APPROVAL	REQUEST FOR COUNCIL ACTION	MEETING DATE 06/19/18
REPORTS & RECOMMENDATIONS	<p>SPECIAL USE AMENDMENT IN PLANNED DEVELOPMENT DISTRICT NO. 37 (THE ROCK SPORTS COMPLEX/BALLPARK COMMONS) PURSUANT TO SECTION 15-3.0442 OF THE CITY OF FRANKLIN UNIFIED DEVELOPMENT ORDINANCE, AND RESOLUTION NO. 2018-7339 A RESOLUTION IMPOSING CONDITIONS AND RESTRICTIONS FOR THE APPROVAL OF A SPECIAL USE FOR A PROPOSED OUTDOOR BASEBALL/SOCCER STADIUM USE UPON PROPERTY LOCATED AT 7900 WEST CRYSTAL RIDGE DRIVE, TO ALLOW FOR CONSTRUCTION AND OPERATION OF THE SECOND OF THREE PHASES OF A PROPOSED STADIUM WITH CAPACITY FOR APPROXIMATELY 4,000 PEOPLE THAT WILL SERVE AS THE HOME FIELD FOR: AN INDEPENDENT MINOR LEAGUE BASEBALL TEAM; THE UNIVERSITY OF WISCONSIN-MILWAUKEE BASEBALL TEAM; AND A PROFESSIONAL AND/OR SUMMER COLLEGE SOCCER TEAM (BPC COUNTY LAND, LLC, APPLICANT)</p>	<p>ITEM NUMBER</p> <p>15.11</p>
<p>At their meeting on June 7, 2018, the Plan Commission recommended approval of a resolution imposing conditions and restriction for a special use amendment for a proposed 4,000 person total capacity outdoor baseball/soccer stadium use upon property located at approximately 7900 W. Crystal Ridge Drive (The

SITE PLAN K - FENCING SITE PLAN
SHEET 13 OF 13

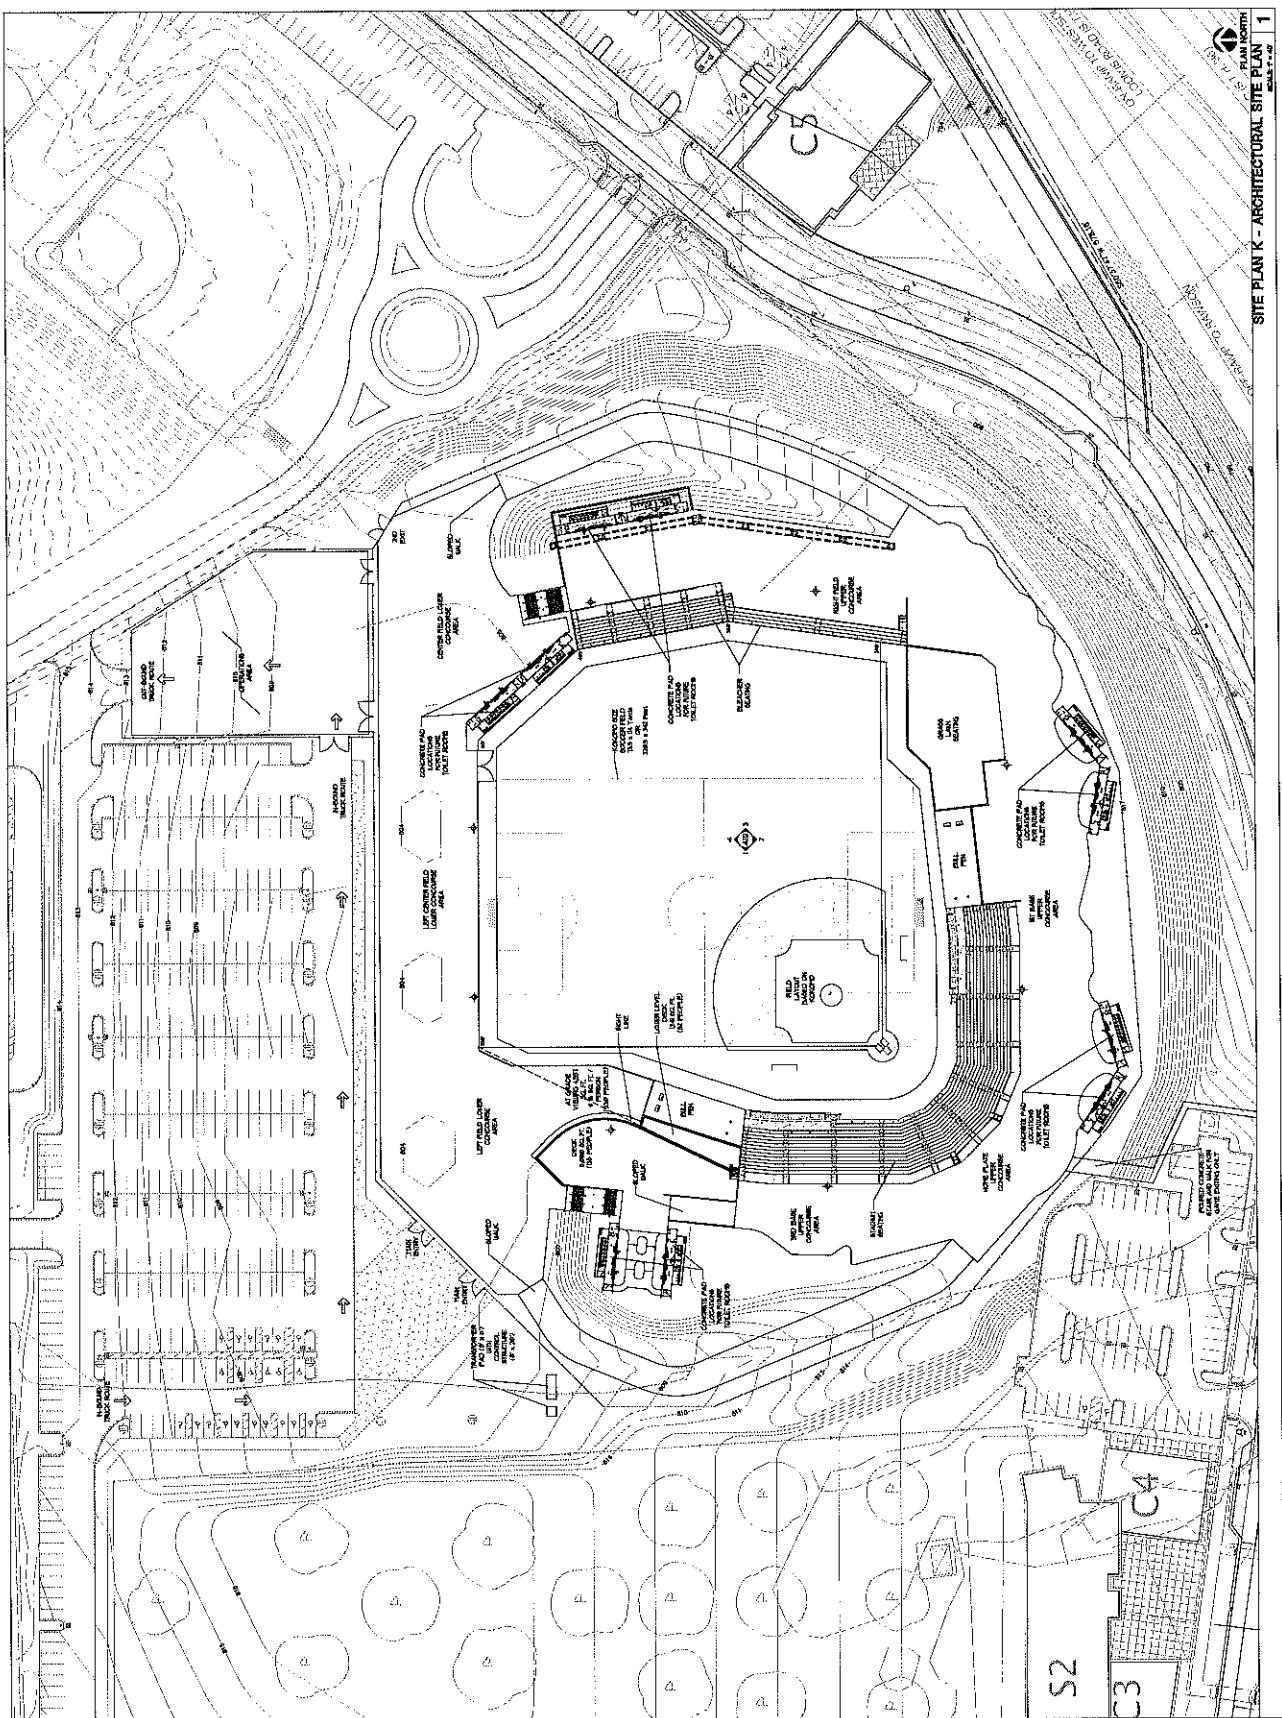
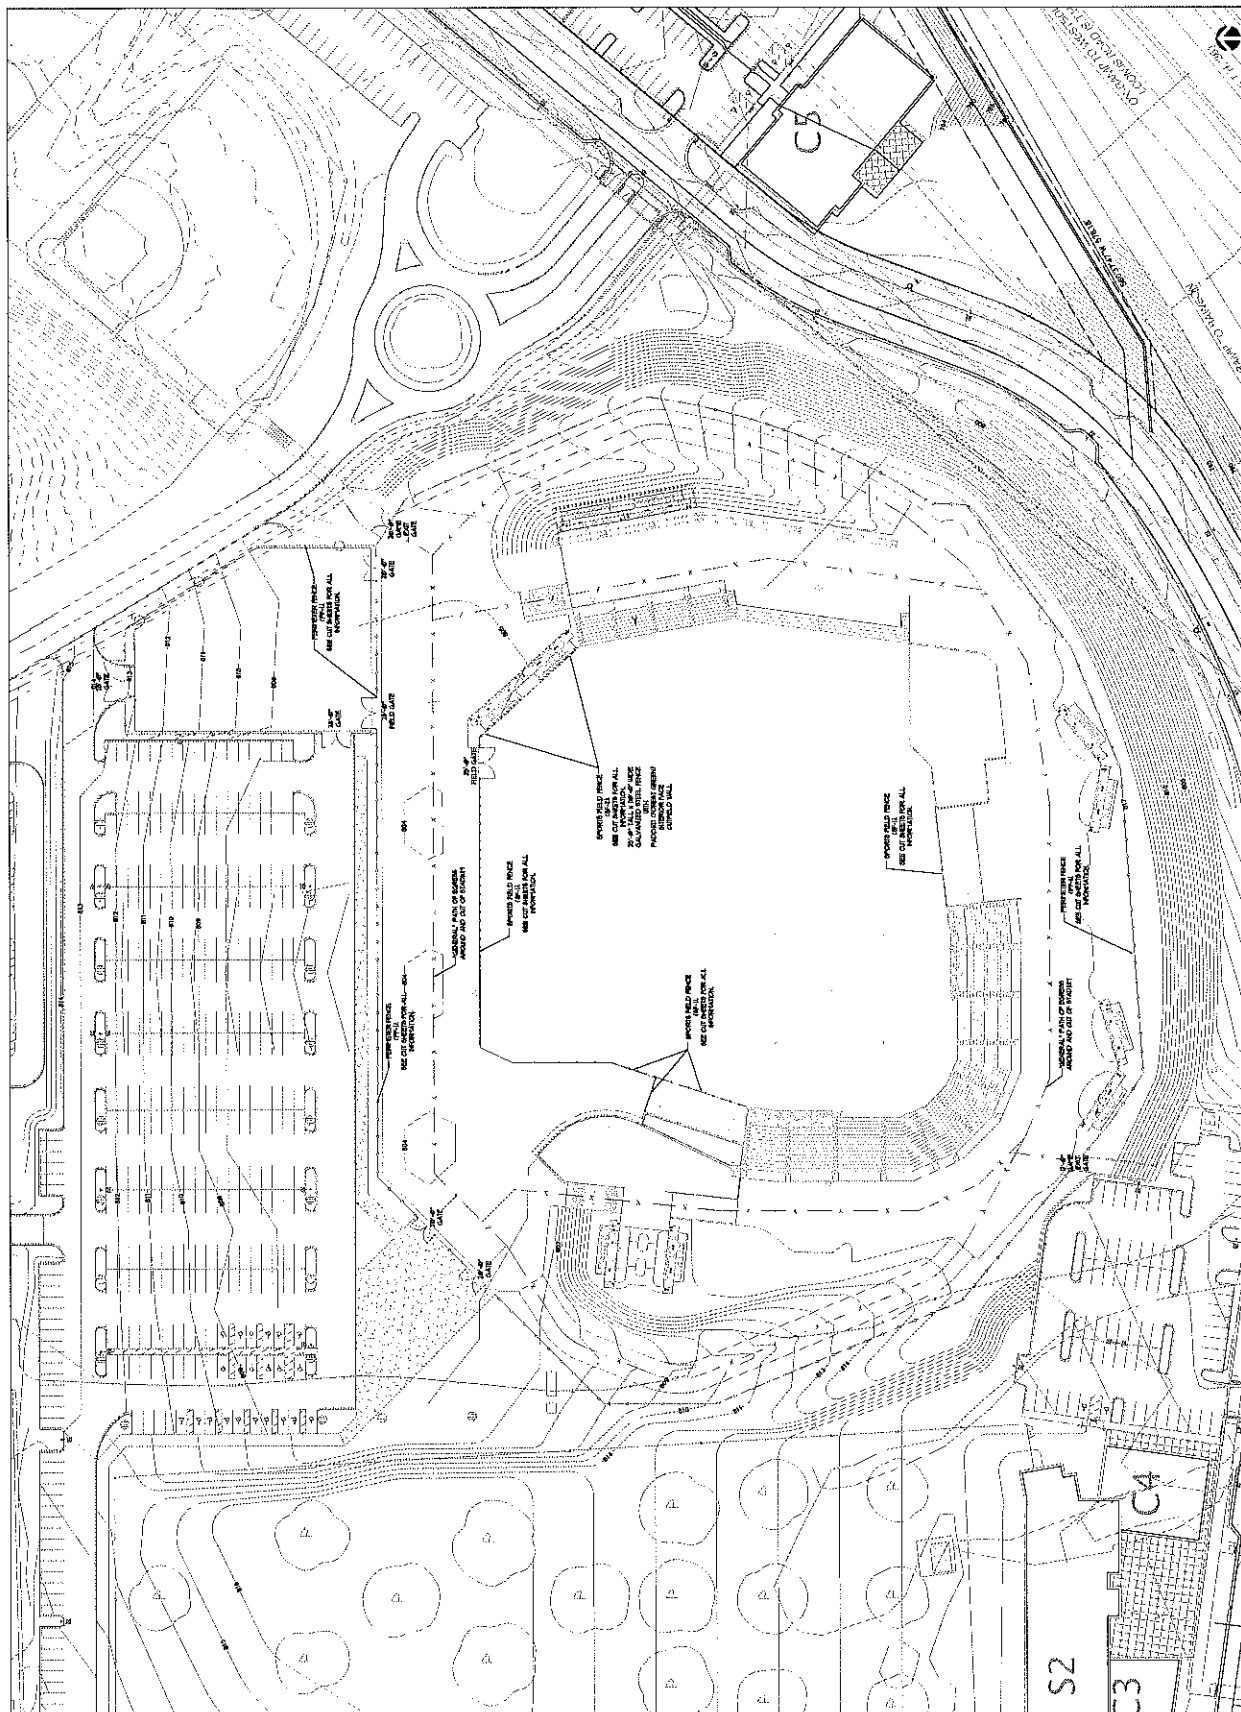
- 3. Page 11, Fencing is not met. Details on all public area fencing must be provided for Plan Commission review and approval.
 - a. Staff recommends that additional details be provided, including but not limited to cut sheets of all fences, gates, etc.

- *Perimeter fencing details have been added to the Civil Plans.*
